Work Order ID 81213

Item Name: 205 Skidtube bent detail

DRAWING NO. D2580	TITLE 205 SKIDTUBE ASSEMBLY	REV. E	DART AEROSPACE LTD ENGINEERING ORDER	D.E.O. NO. D2580-E-1	SHEET NO. SHEET 1 OF 1	SCALE NTS
DRAWN <i>UP</i>	CHECKED <i>ASS</i>	MFG. APPR. <i>ER</i>	APPROVED <i>HA</i>	DE APPR. <i>HA</i>		
DATE 11.12.13	DATE 11.12.13	DATE 11.12.13	DATE 11.12.13	DATE 11.12.13	DATE 11.12.13

CHANGE ALL C'BORED WELDED CROSSBOLT SPACERS TO SWAGED SPACERS

SECTION B-B D5-2
SCALE 5X

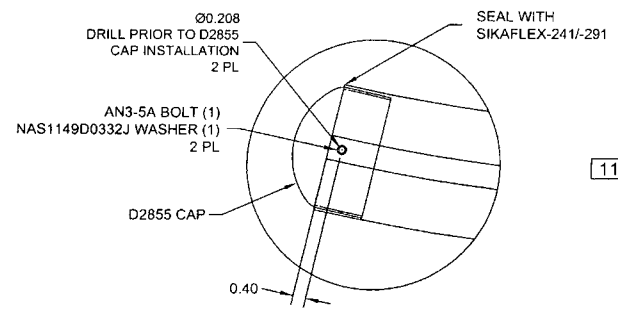
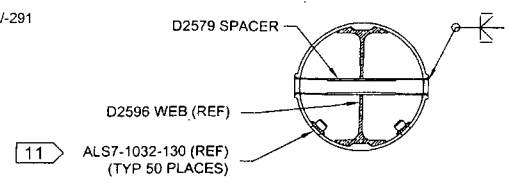
AFTER DRILLING AND BENDING ASSEMBLY
PERFORM THE FOLLOWING FOR Ø0.508 HOLES ONLY:
1. CHAMFER HOLE 0.050 X 45°
2. INSERT D2579 SPACER (20 PLACES)
3. WELD INTO PLACE AND GRIND FLUSH
4. C-BORE D2579 SPACER TO Ø0.437 X 1.00 DEEP

1. INSERT D4202-1 SPACER, 20 PL (-041) OR 20 PL (-045) OR 25 PL (-047)
2. SWAGE TO Ø0.437 X 1.00 DEEP PER QSI 002
3. TRIM / GRIND FLUSH PER QSI 002

SECTION B-B, F-F, I-I
NOT TO SCALE

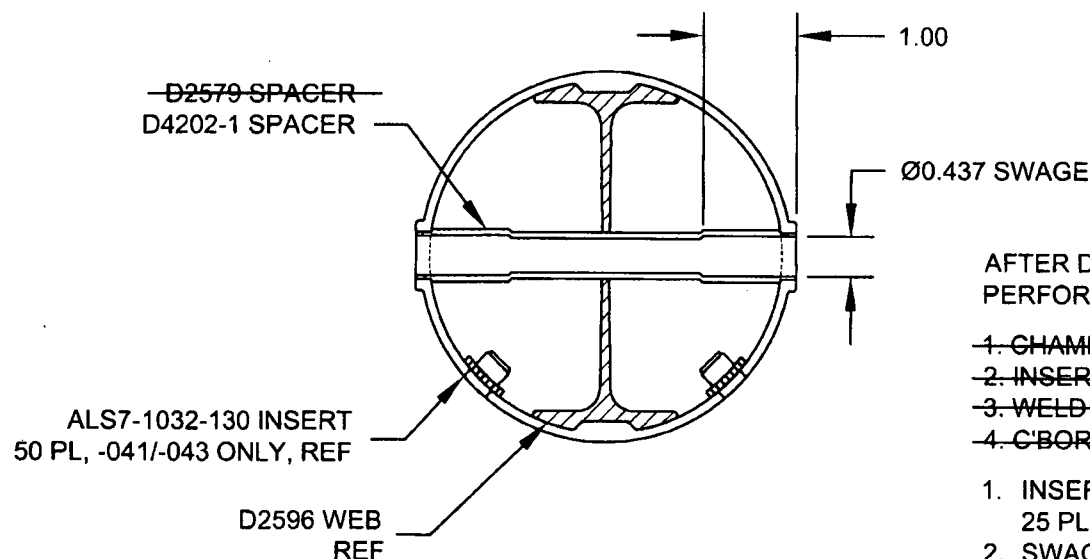
SECTION B-B, SECTION F-F, & SECTION I-I ARE AMENDED AS FOLLOWS
FOR ALL HOLES THAT WERE ORIGINALLY C'BORED:

AFTER DRILLING AND BENDING ASSEMBLY
PERFORM THE FOLLOWING FOR Ø0.508 HOLES ONLY:

1. CHAMFER HOLE 0.050 X 45°
2. INSERT D2579 SPACER (20 PLACES)
3. WELD INTO PLACE AND GRIND FLUSH
4. C'BORE D2579 SPACER TO Ø0.437 X 1.00 DEEP

WELD 4X D2579 SPACERS PER DWG
IN LOCATIONS MARKED "NO C'BORE".
REF SHEET 4 OF DWG.
